**Site Plan Amendment:  
Asphalt Paving**

**AMENDED SITE PLAN FOR  
 H & A VETERINARY ASSOCIATES  
 FOR NEW OFFICE BUILDING**

TAX MAP # 07-6066-02-878695  
 4938 ALBANY POST ROAD  
 TOWN OF HYDE PARK  
 DUTCHESS COUNTY, NEW YORK

Revised: 12/28/16, 01/29, 02/21 & 03/28/17 AMENDED: February 27, 2018

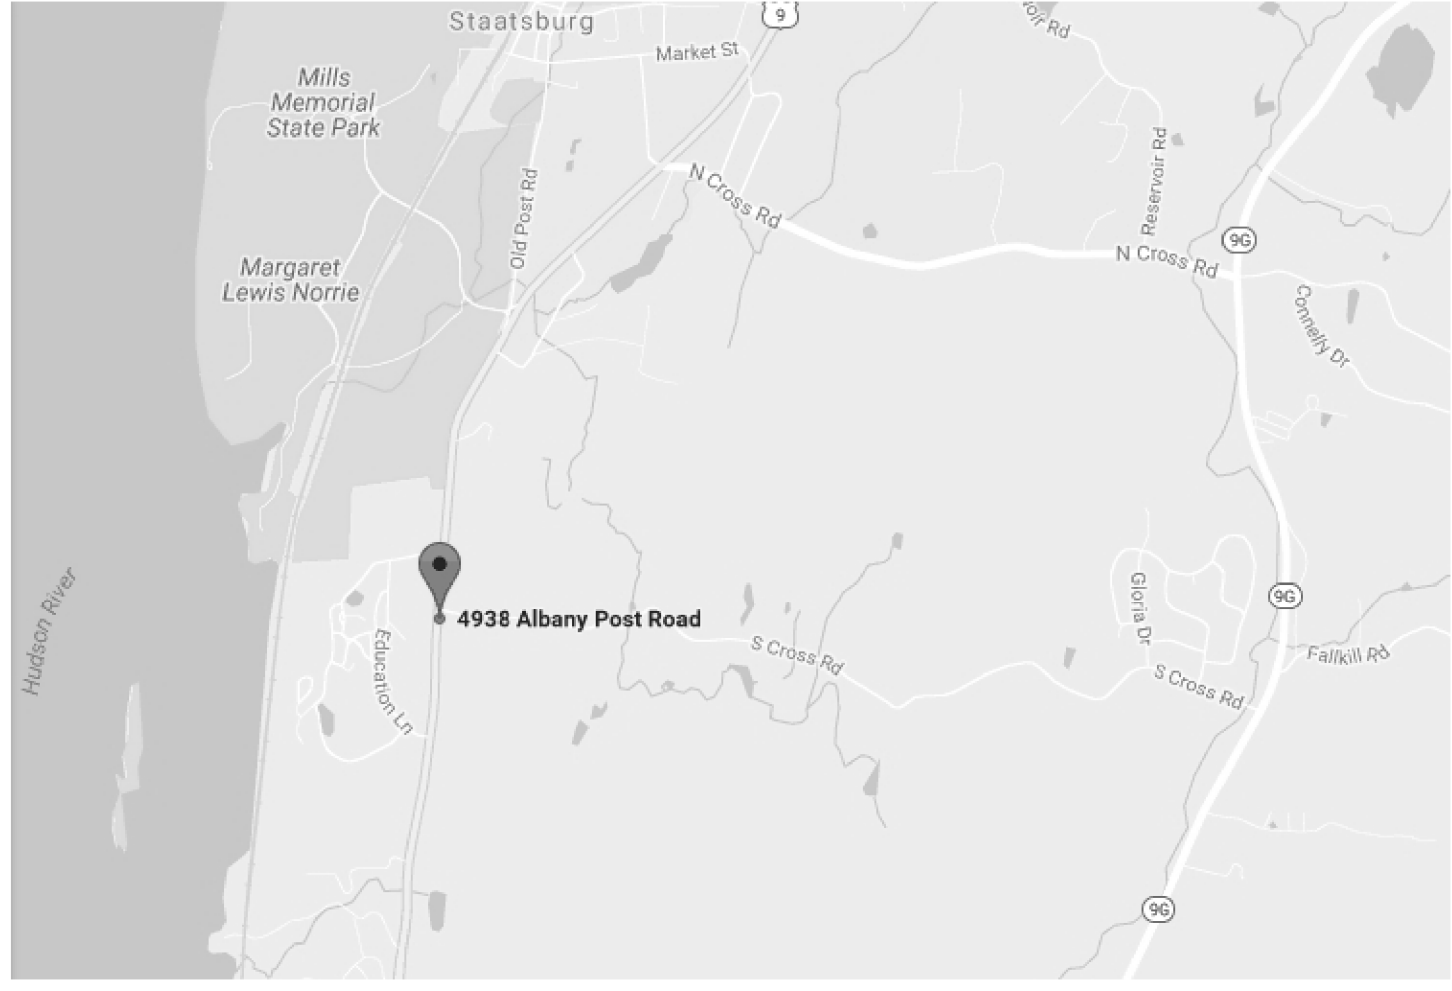
- The driveway entrance and the entire parking lot shall be paved.
- The existing material/gravel will serve as the subbase material. Contractor shall add Item 4 as necessary. All material shall be compacted prior to paving operation commences.
- (2) Asphalt Courses = 2" Binder Course, 1 1/2" Top Course.
- The top Parking Lot area shall be graded such that the storm water shall sheetflow to the grass area at the south end of the property.
- The driveway entrance shall drain to catch basins at the base of the driveway and be outletted into the 24" RCP cross-drain.
